SUBJECT: ADMINISTRATIVE CHANGES TO UPDATE THE TECHNICAL SPECIFICATIONS
(TAC NOS. 64694/64695)

RE: SUSQUEHANNA STEAM ELECTRIC STATION, UNITS 1 AND 2

AMENDMENT TO FACILITY OPERATING LICENSE

Amendment No. 82
License No. NPF-14

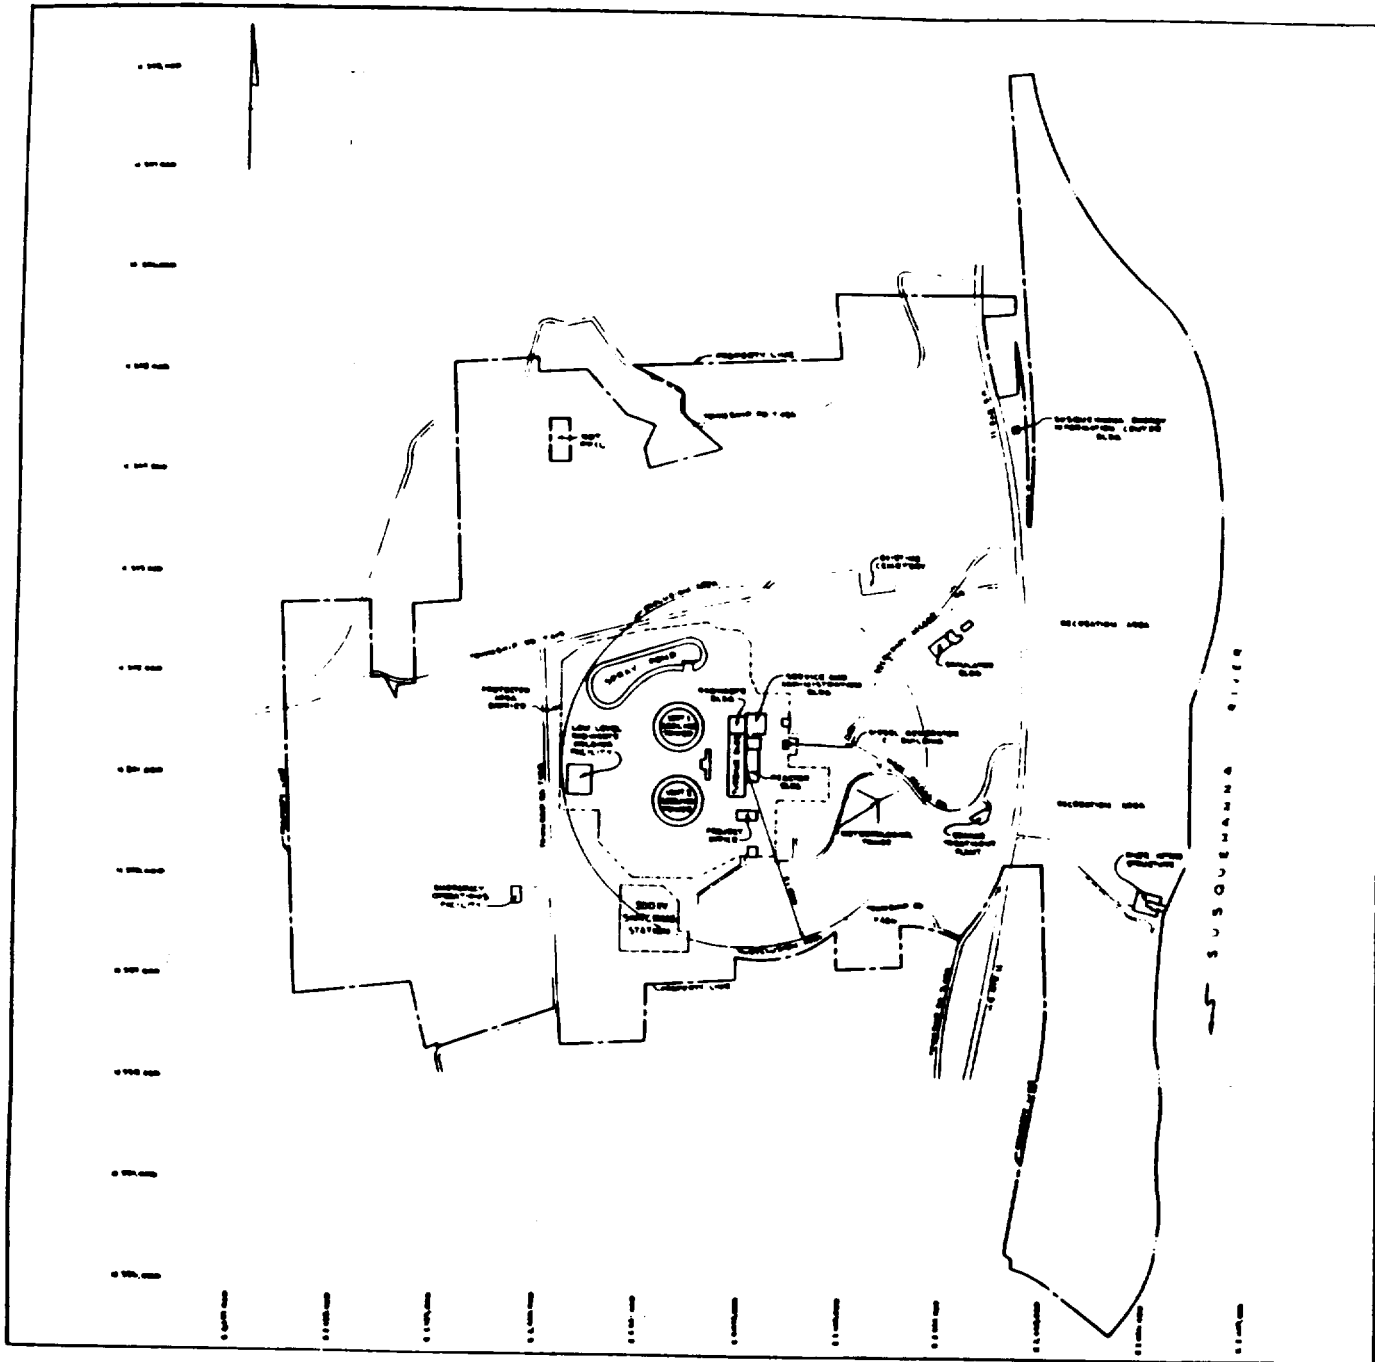
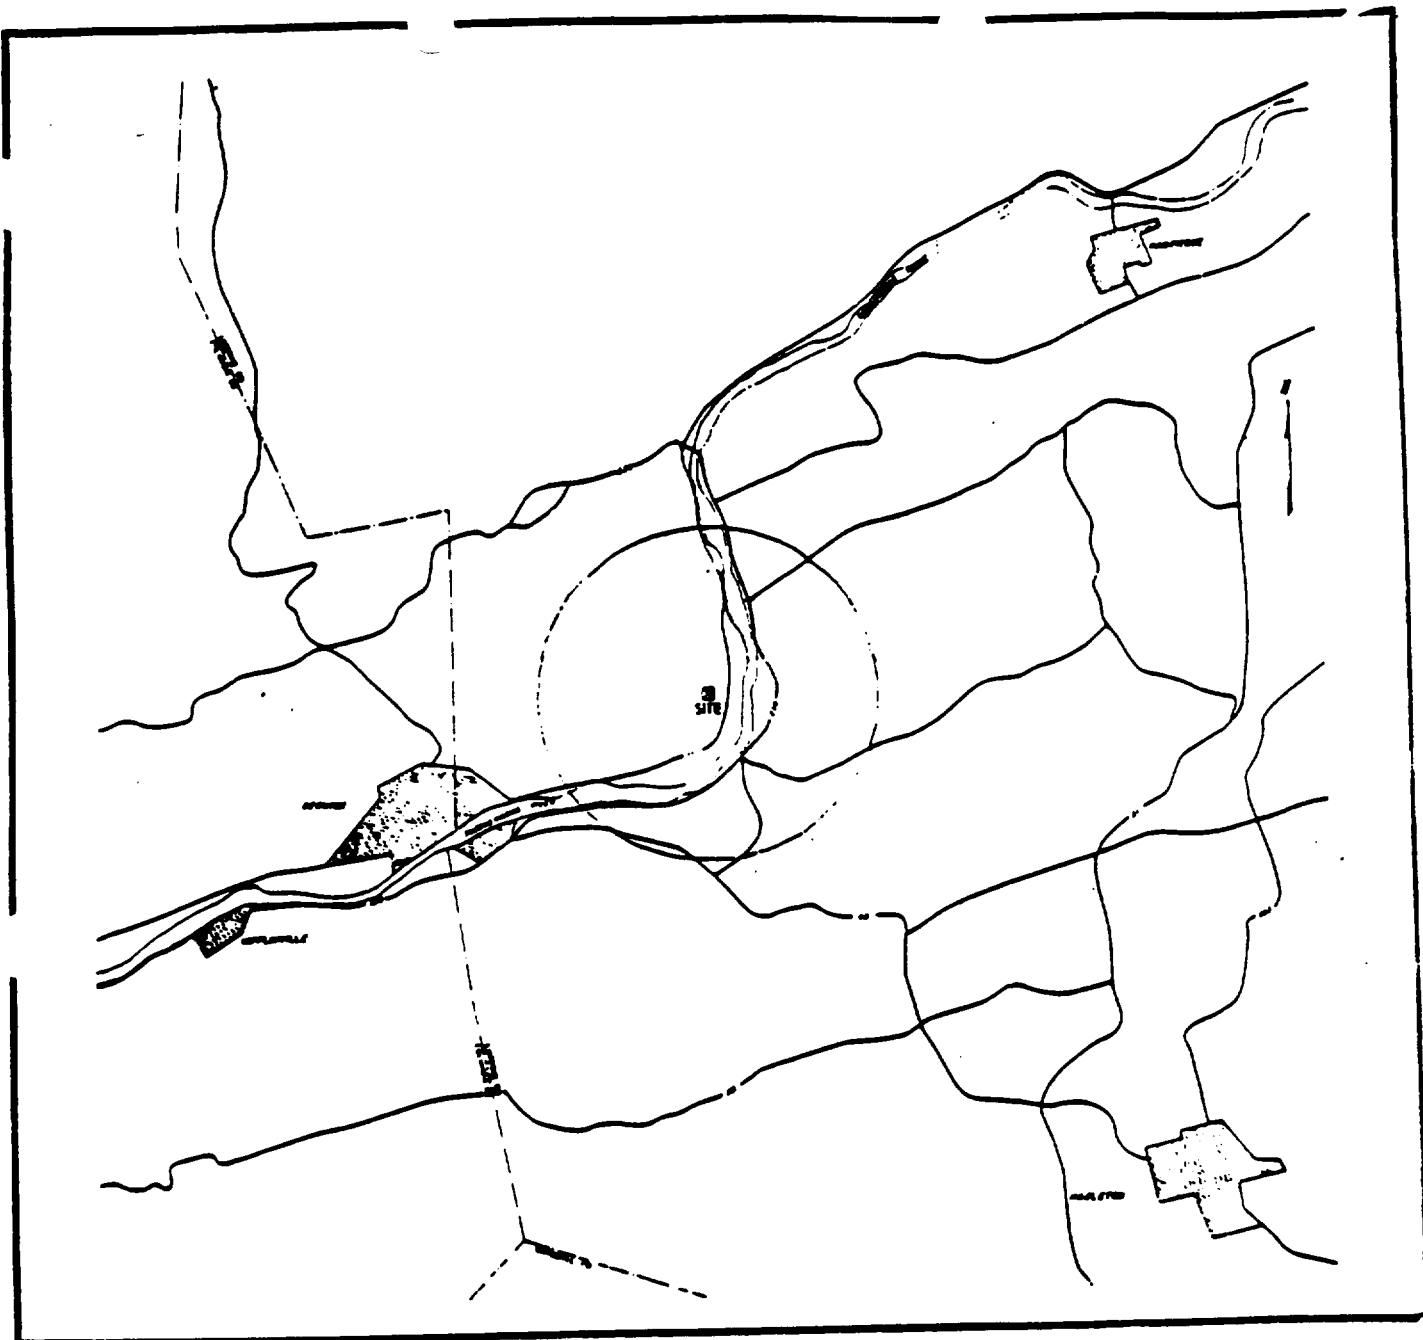
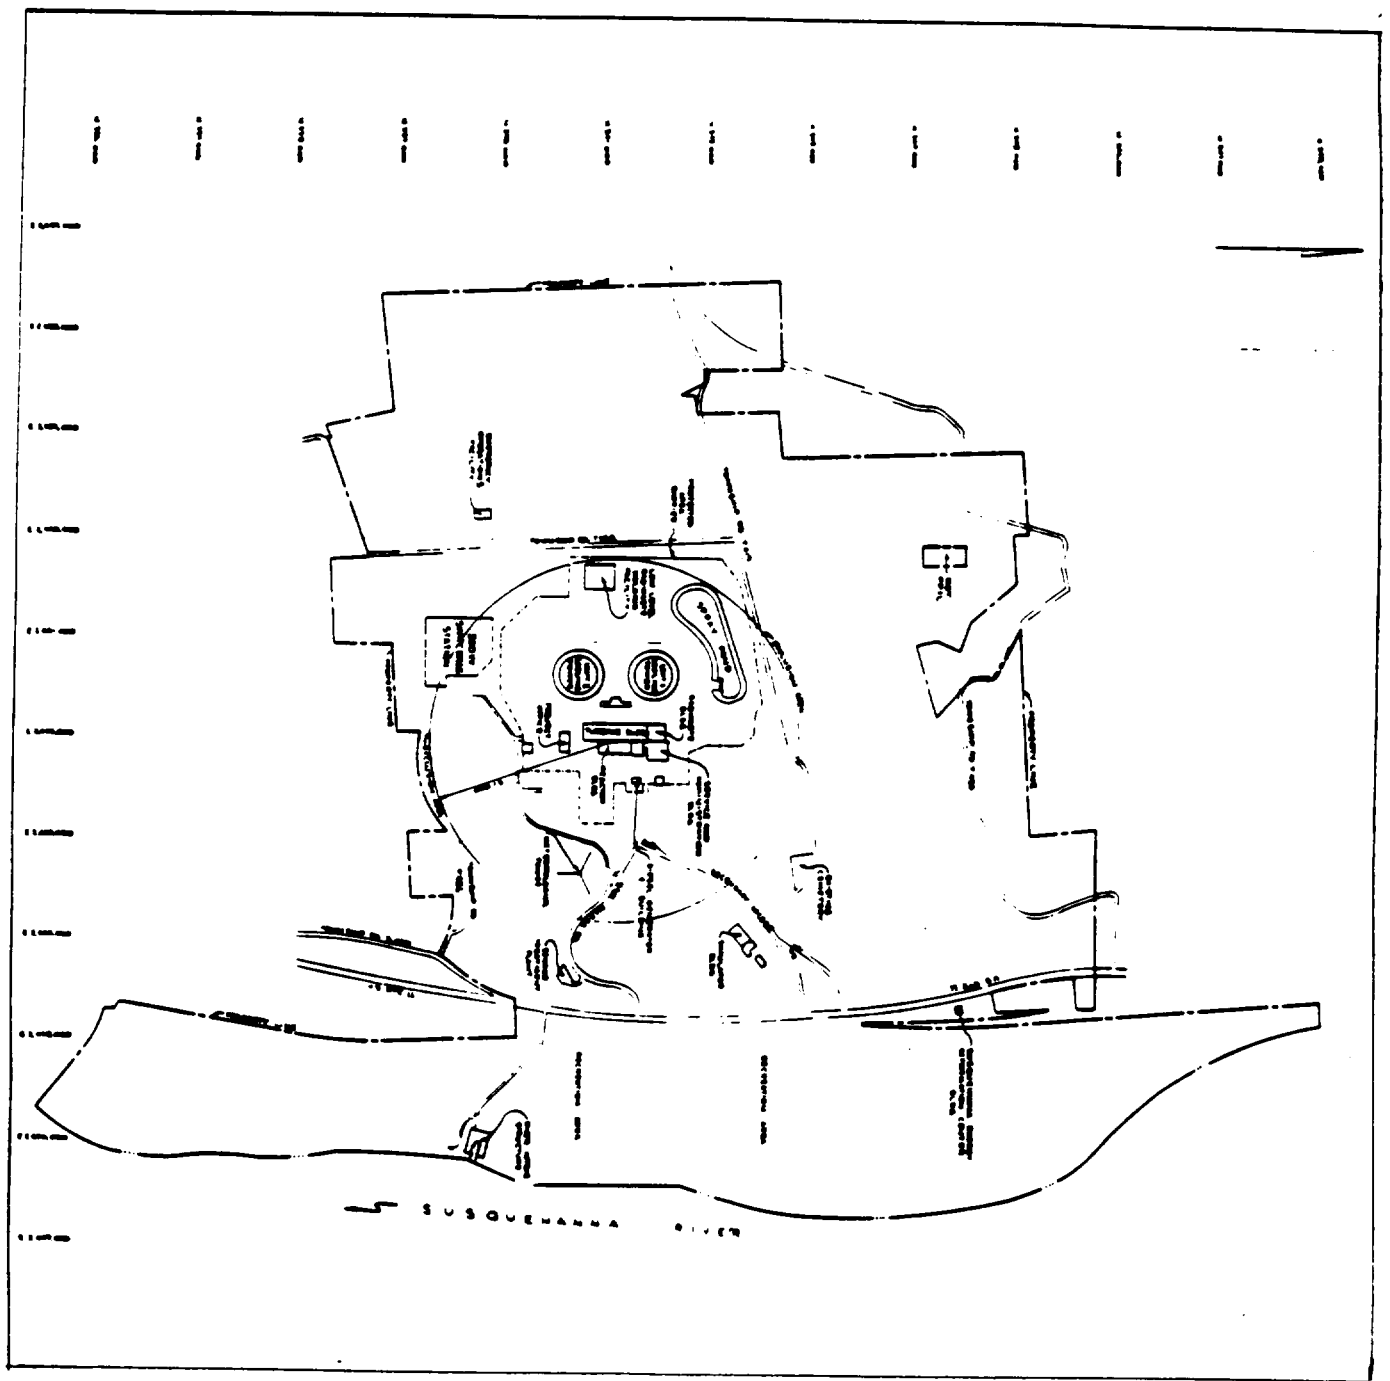
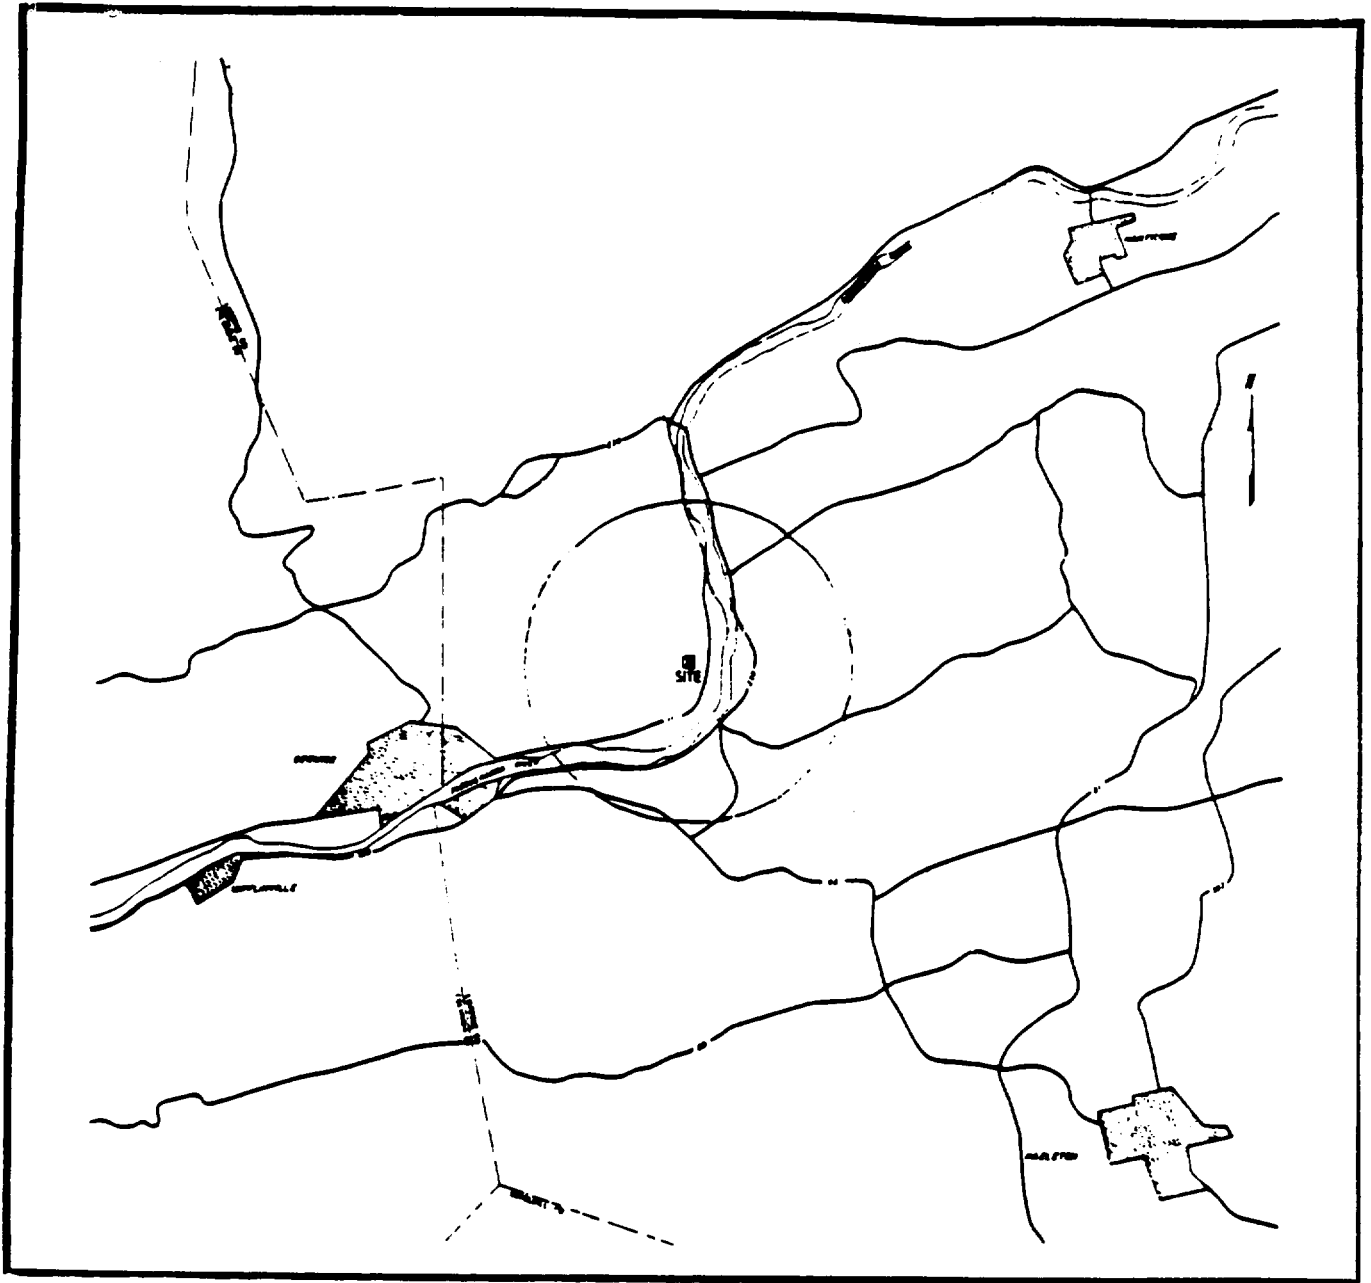
- ° 5 deletions of dated requirements which have been completed
- ° Two changes updating site drawings to show new construction
